SUBJECT: Forwards responses to 851025 request for addl info re SPDS.
 Review & issuance of SSER requested. Display design modified
 such that Class 1E multiplexer cards powered from Class 1E
 power within div.

SHEARON HARRIS NUCLEAR POWER PLANT
UNIT NO. 1 - DOCKET NO. 50-400
SAFETY PARAMETER DISPLAY SYSTEM

Carolina Power & Light Company submits responses to your staff's request for additional information identified in the NRC's Safety Evaluation Report (SER) for the Shearon Harris Nuclear Power Plant Safety Parameter Display System (Reference 1). Please review these attached responses and issue a supplemental SER.

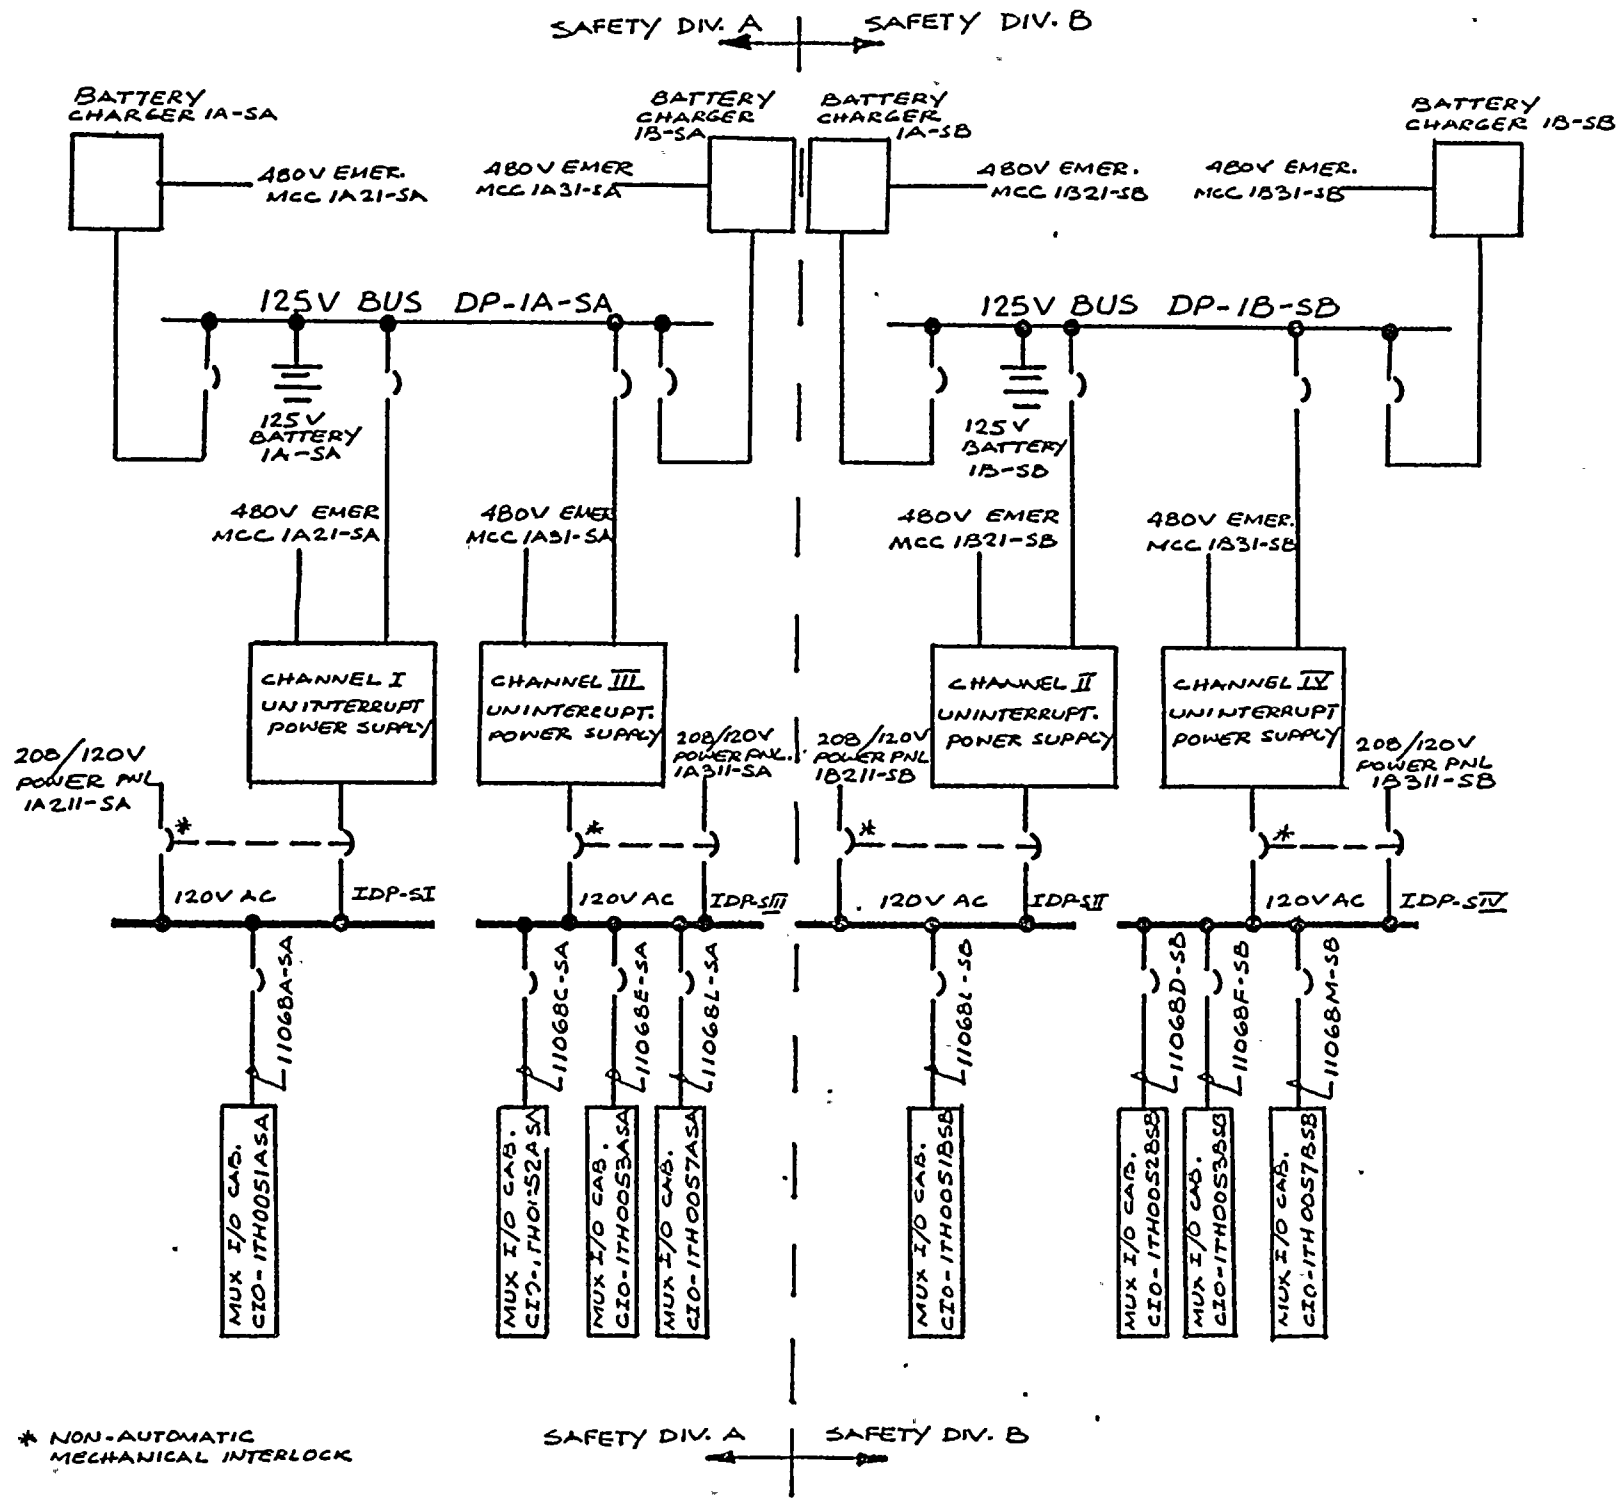
Modify the display's design such that the Class 1E multiplexer cards be powered from Class 1E power within their division. This modification shall be completed prior to declaring the safety systems operational for the plant. Documentation to support this modification should be submitted to the NRC for confirmatory review.

The display's design has been modified such that the Class 1E multiplexer cards are powered from Class 1E power within their division. Documentation to support this modification is attached. The modification will be completed prior to fuel load.

FIGURE 1-1
ERFIS/SPDS EFFORT

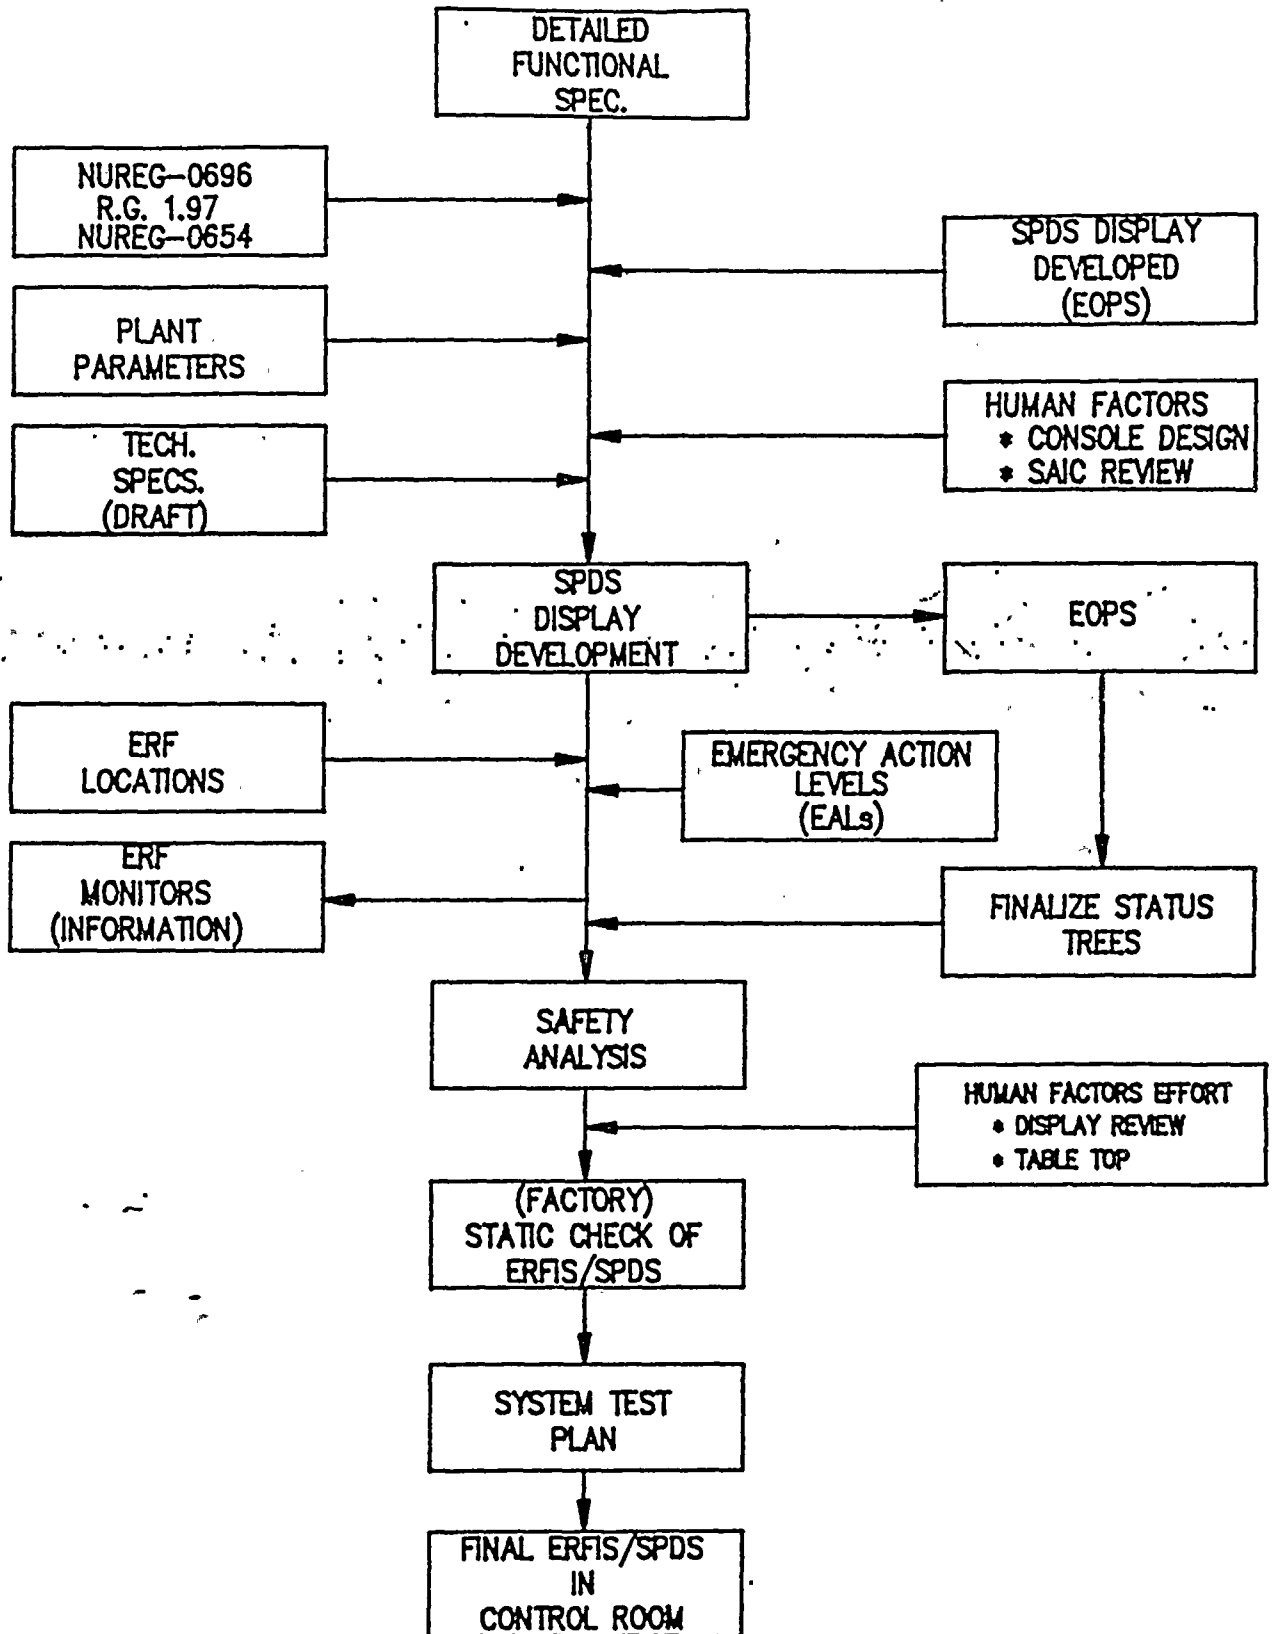
A Validation Test Report which describes test results and plans for resolution of problems identified during the test program.

CP&L has a high degree of confidence that the Final Validation Test Report will demonstrate that the SHNPP SPDS is an extremely well designed computer system. The SPDS has been developed from the top down as shown in the attached figure. Additionally, hardcopy outputs of the as-designed SPDS have been used on the Harris simulator with great success and acknowledged by the NRC staff in a Trip Report dated May 22, 1984. The Final Validation Test Report will be available prior to startup following the first refueling outage.

Figure 2-1

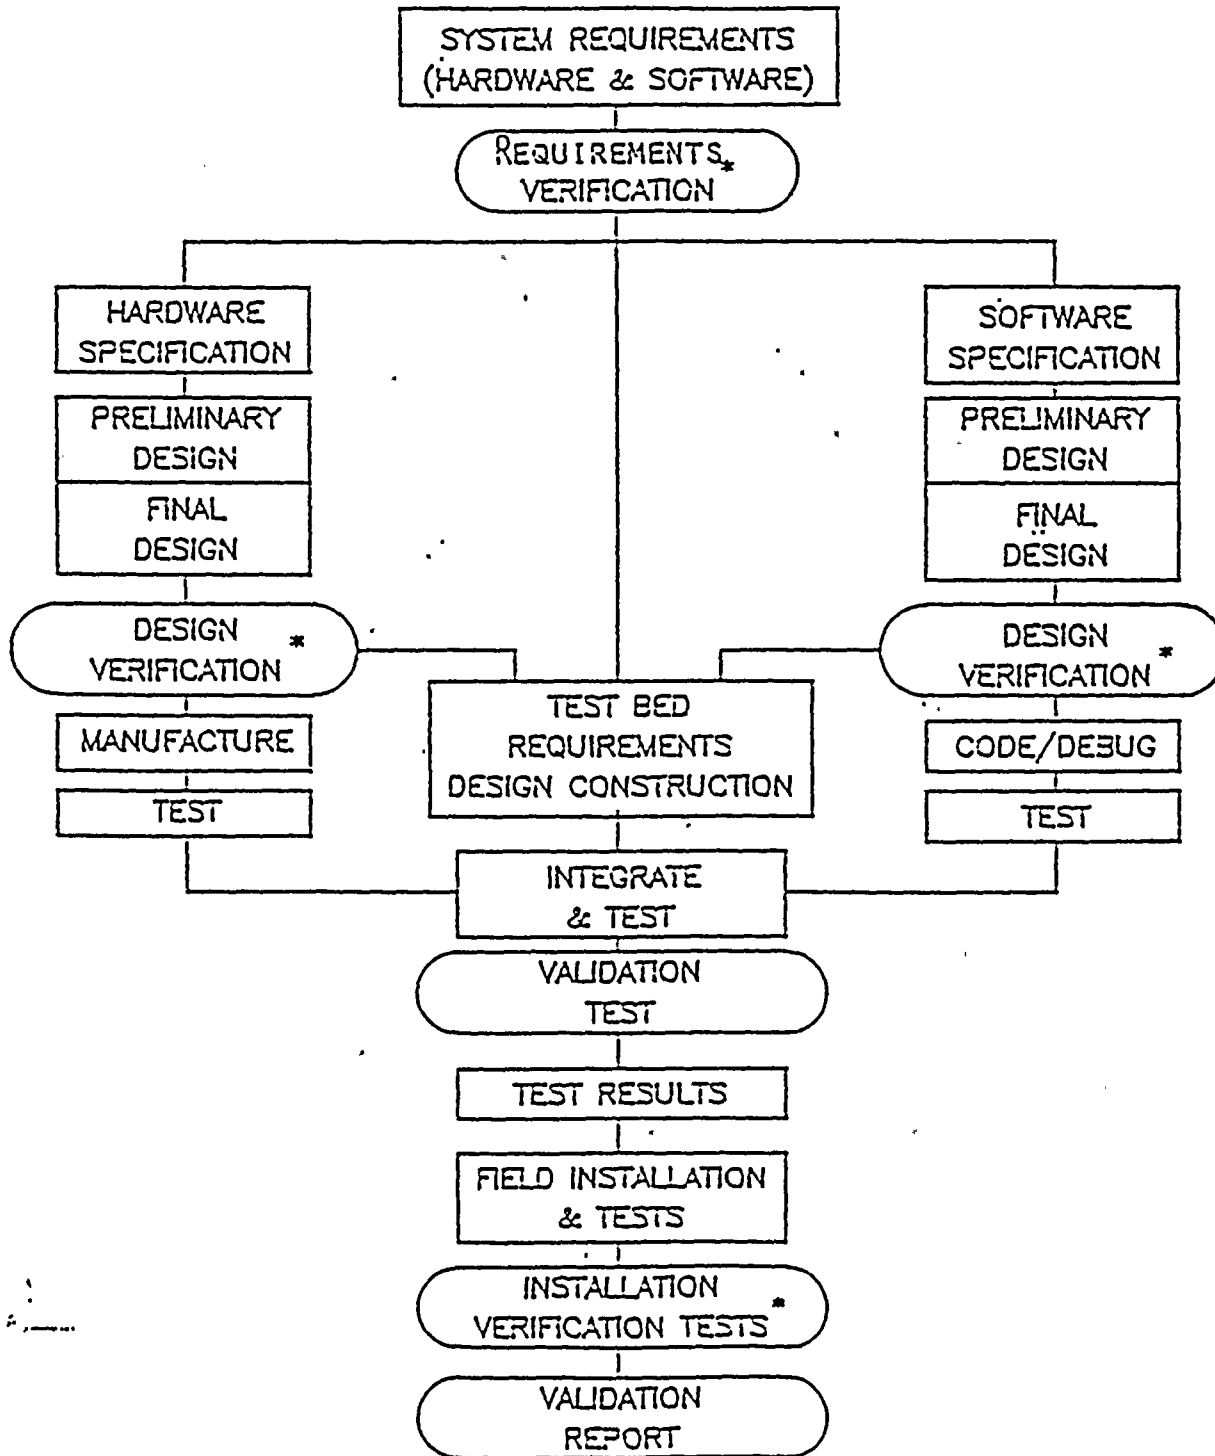
Submit the Verification and Validation Program Plan for docketing.

Figure 2-1 shows the V&V activities in relation to generic system development activities.
